Beam Interlock System Audit

Report on the Audit held in September 2006

The Beam Interlock System (BIS)

Report on the audit held on September 18th-25th 2006.

Optical Loop I

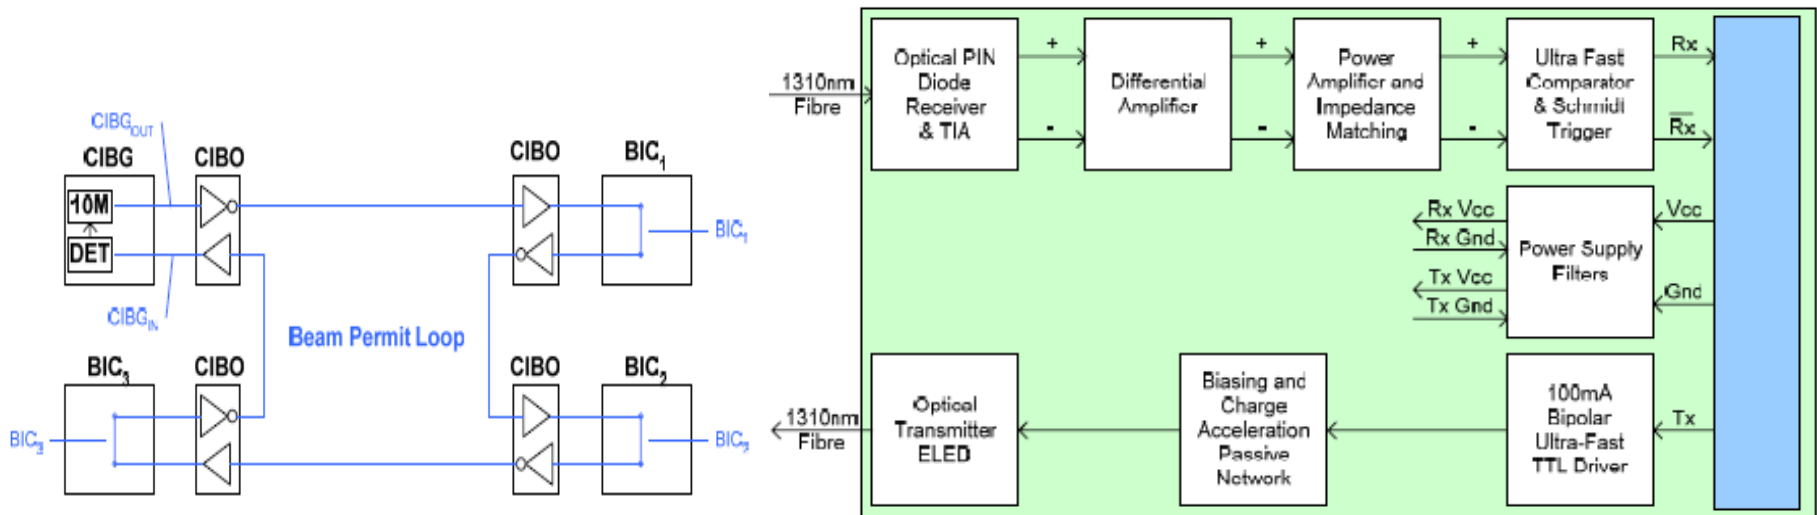
Severe denial-of-service due to spurious signals on optical fiber link:

- ELED driver amplified power supply ripples on the “high” state after the signal inversion, transmitted by the ELED, and amplified and shaped by the PIN diode receiver circuit.

13. A solution should be found to avoid this behavior.

14. The availability of the “old-fashioned” ELED seems to present a potential problem.

Interfaces I

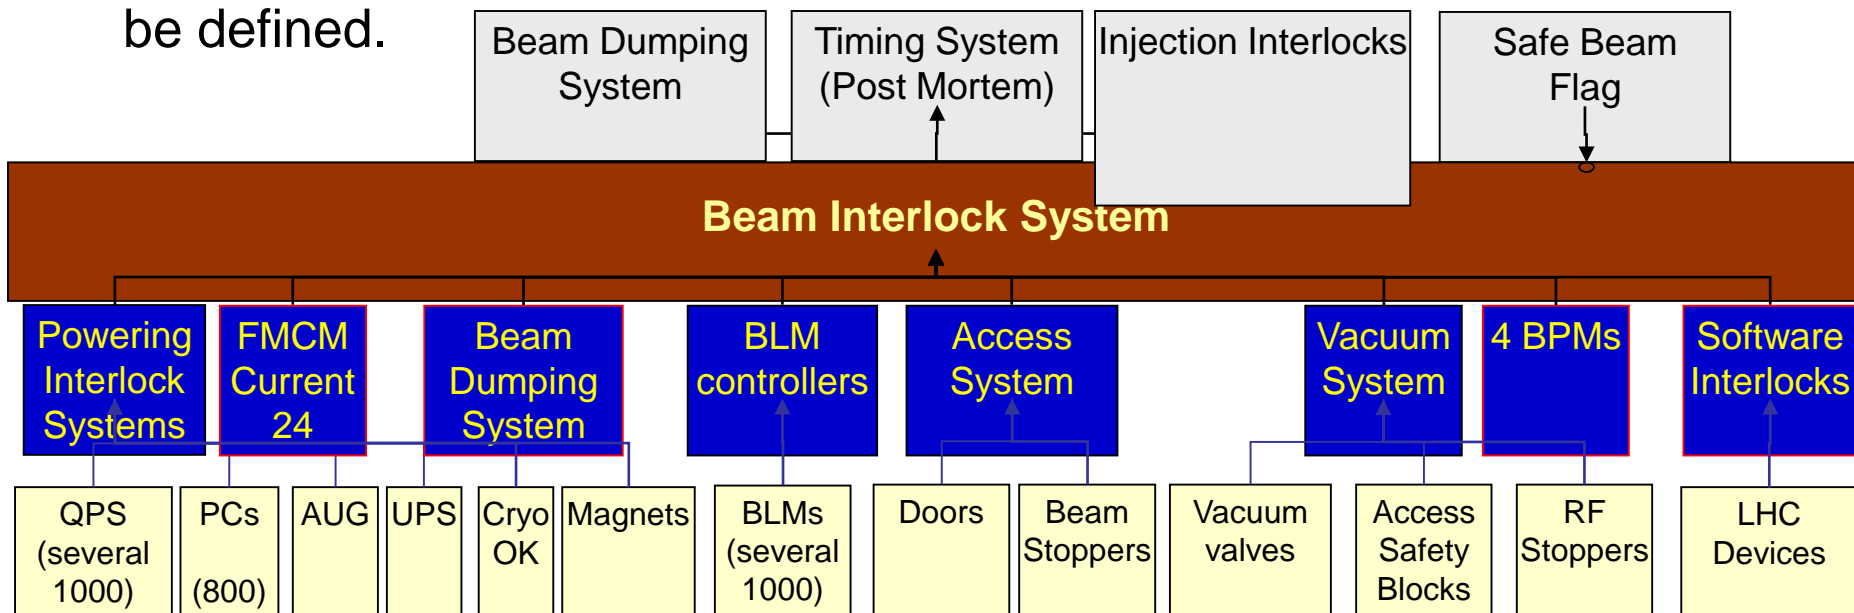
LHC safety is only as good as its weakest element:

35. Clear procedures for testing the *full* BEAM_PERMIT-signal chain should be defined.
